Re: St. Lucie Unit 2
Docket No. 50-389
Proposed License Amendment
RCS Pressure/Temperature Limits

St. Lucie Unit 2 Marked-up Technical Specification Page

FIGURE 3.4-2 ^{21.7}
ST. LUCIE-2 P/T LIMITS, 1/8 EPY
HEATUP AND CORE CRITICAL

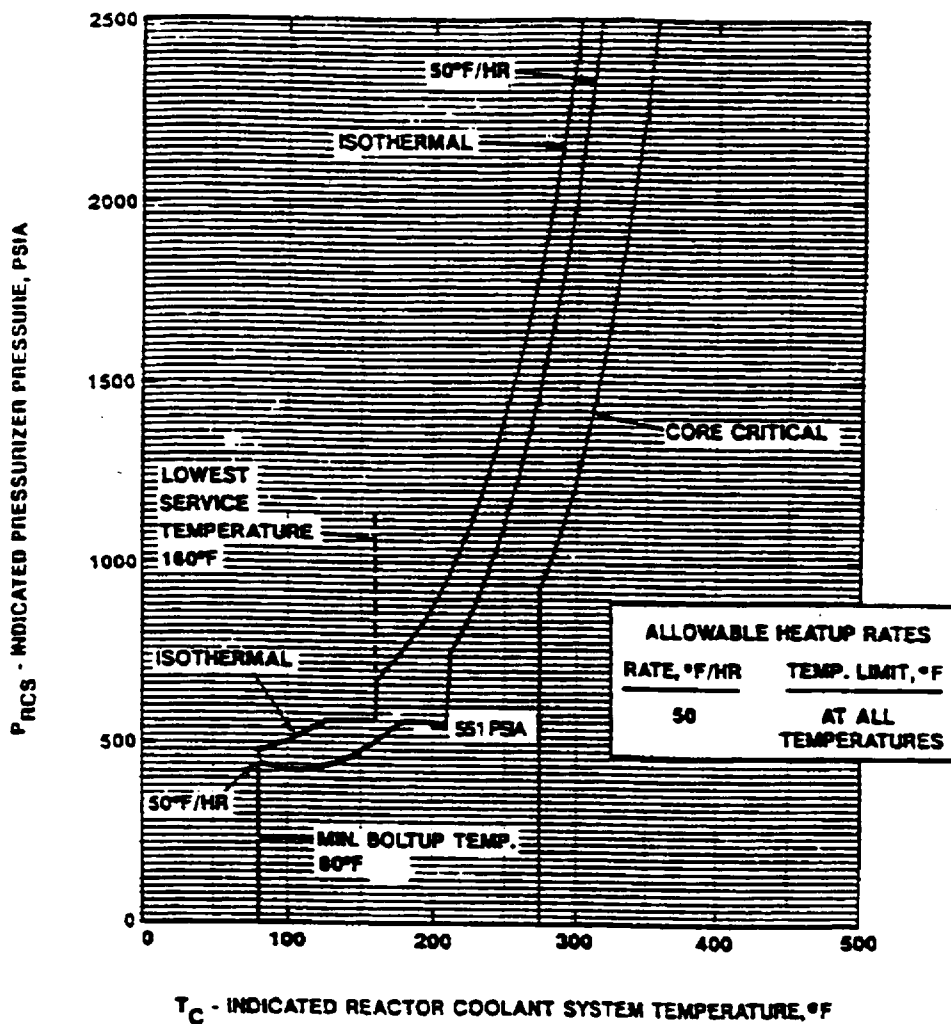
2. LCO 3.4.9.1 currently provides the pressure and temperature limits in terms of Figures 3.4-2, 3.4-3, and 3.4-4 for the RCS (except the pressurizer) during heatup, cooldown, criticality, and inservice leak and hydrostatic testing for 15 EFPY. The proposed amendment would use these existing figures, as-is, and only revise the title by changing **15 EFPY** to **21.7 EFPY**.

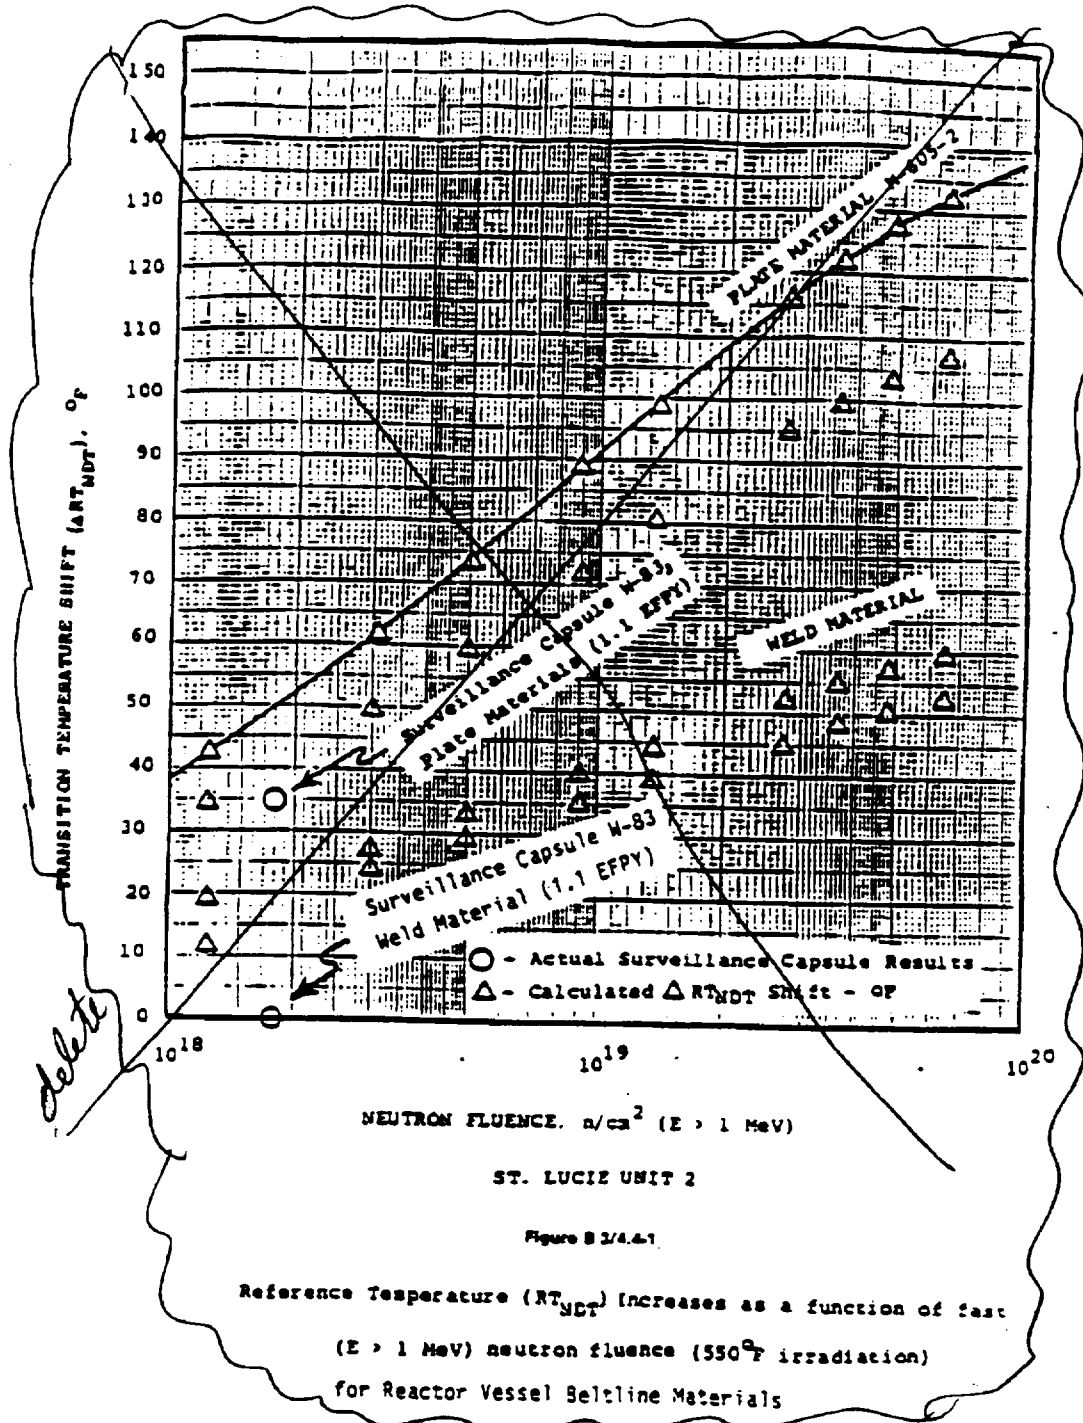
4. Changed the TS 3/4 4.9 Bases as indicated to be consistent with this proposed amendment. The change to the Bases deletes the obsolete Figure B3/4.4-1 on page B3/4 4-10.

Delete
